PREVOST

WARRANTY BULLETIN

WB15-13

DATE :	MARCH 2015	SECTION :	16 - Suspension
EXPIRATION:	MARCH 2017		
SUBJECT :	IFS LEVEL VALVE CONTROL ROD POSSIBLE CONTACT

Figure 2

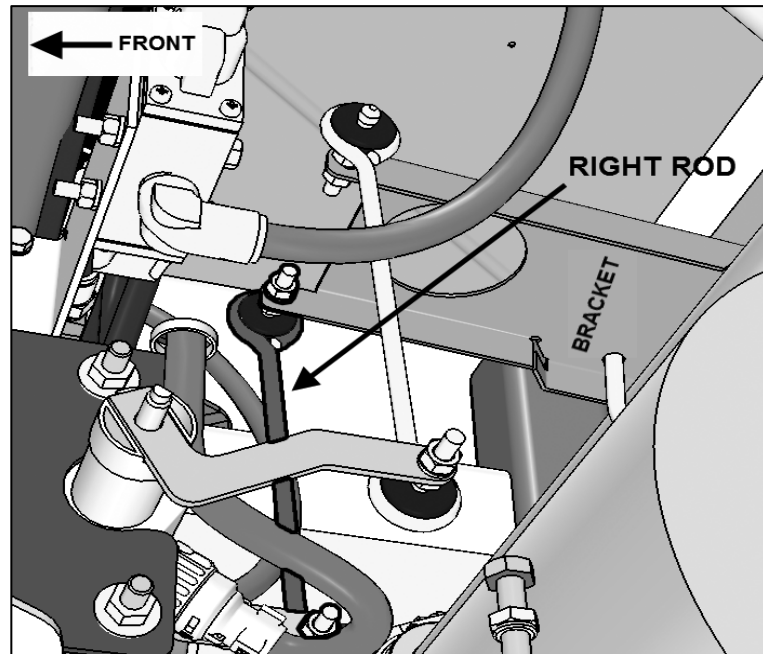
2. In the middle of the sway bar you will find a bracket clamped on the tube. The bracket supports two control rods (Fig. 2)

3. On the right hand side rod. (Fig.2) Unscrew the upper and lower mounting nuts.
4. Flip the rod over to the opposite side of the control lever and bracket tab above. (Arrow, Fig. 3)
5. Re-assemble hardware. (Fig.3)

Figure 3 : Flip upper and lower connection of control rod.

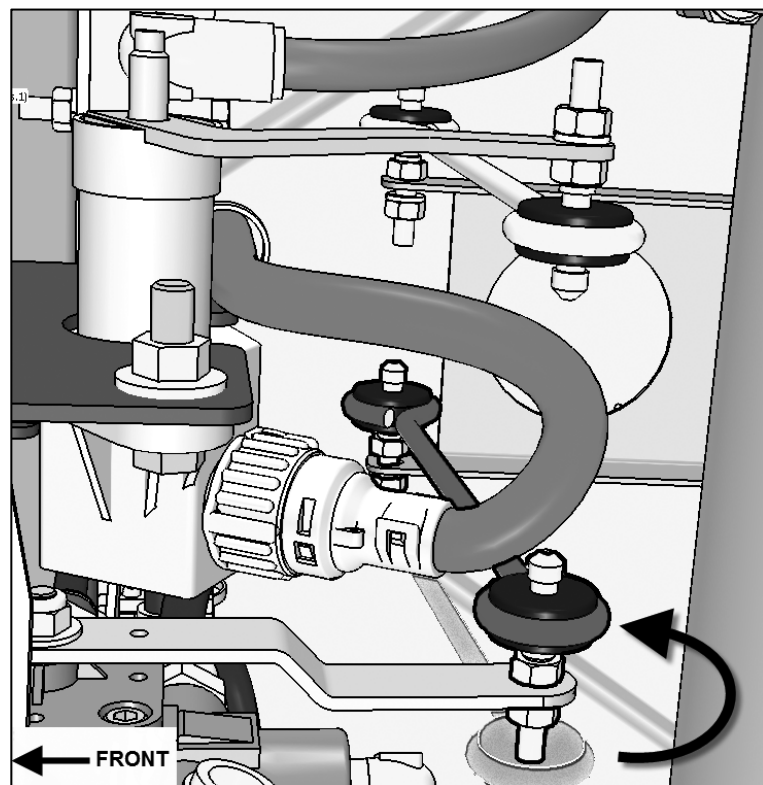
The interference is corrected by changing the side on which the rod is attached to the linkage.
